### 3/4.4 REACTOR COOLANT SYSTEM

#### 3/4.4.1 RECIRCULATION SYSTEM

##### RECIRCULATION LOOPS

FIGURE 3.4.1.1-1

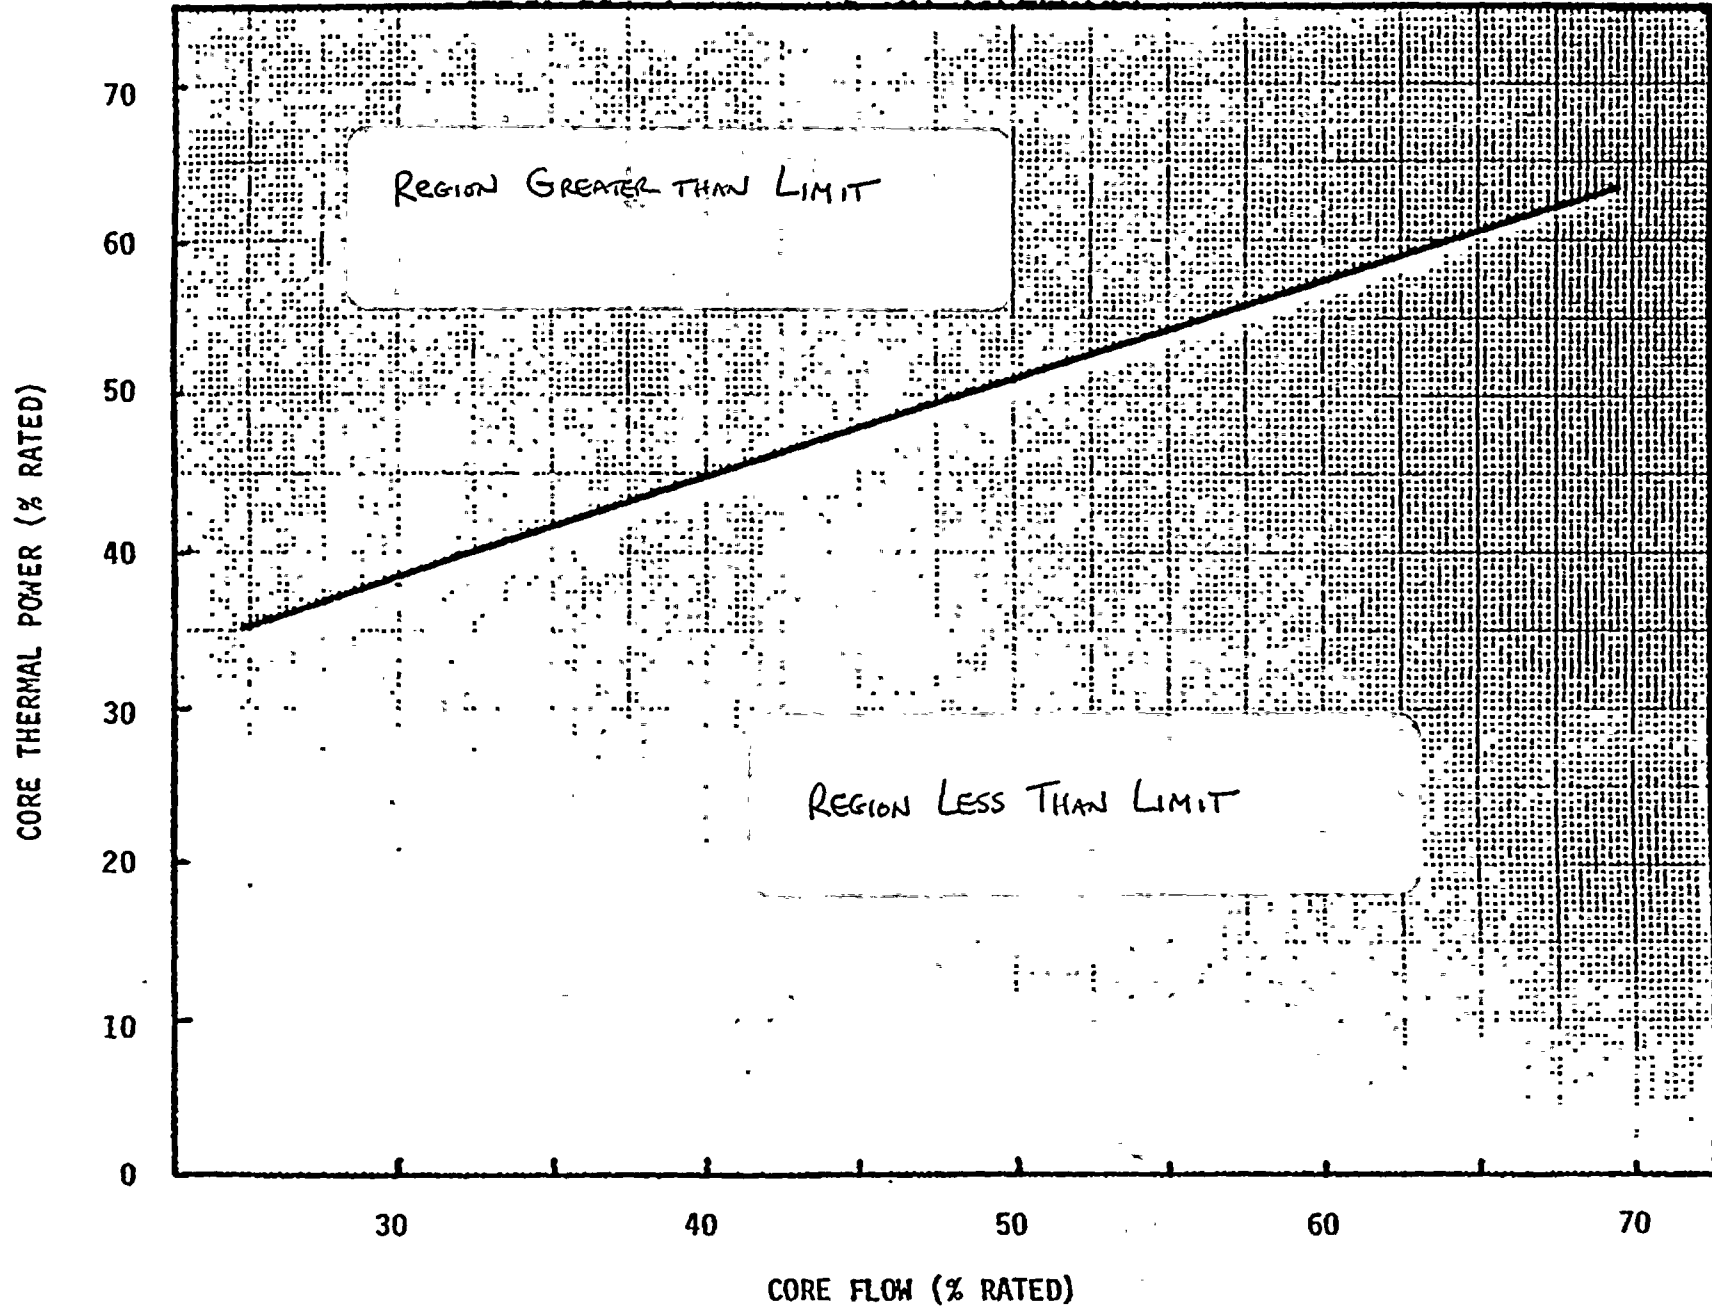
- a. total core flow shall be greater than or equal to 45 million lbs/hr, or
- b. THERMAL POWER shall be less than or equal to the limit specified in Figure 3.4.1.1-1.

- a. With one reactor coolant system recirculation loop not in operation, immediately initiate an orderly reduction of THERMAL POWER to less than or equal to the limit specified in Figure 3.4.1.1-1, and be in at least HOT SHUTDOWN within the next 12 hours.

- b. With no reactor coolant system recirculation loops in operation, immediately initiate an orderly reduction of THERMAL POWER to less than or equal to the limit specified in Figure 3.4.1.1-1, and initiate measures to place the unit in at least STARTUP within 6 hours and in HOT SHUTDOWN within the next 6 hours.

- c. With two reactor coolant system recirculation loops in operation and total core flow less than 45 million lbs/hr and THERMAL POWER greater than the limit specified in Figure 3.4.1.1-1:

1. reduce THERMAL POWER to less than or equal to the limit specified in Figure 3.4.1.1-1, or
  2. increase core flow to greater than 45 million lbs/hr, or

3. determine the APRM and LPRM\*\*\* neutron flux noise levels within 1 hour, and:
    - a) if the APRM and LPRM\*\*\* neutron flux noise levels are less than three times their established baseline levels, continue to determine the noise levels at least once per 8 hours and within 30 minutes after the completion of a THERMAL POWER increase of at least 5% of RATED THERMAL POWER, or

- b) if the APRM or LPRM\*\*\* neutron flux noise levels are greater than or equal to three times their established baseline levels, immediately initiate corrective action and restore the noise levels to within the required limits within 2 hours by increasing core flow to greater than 45 million lbs/hr, and/or by initiating an orderly reduction of THERMAL POWER to less than or equal to the limit specified in Figure 3.4.1.1-1.
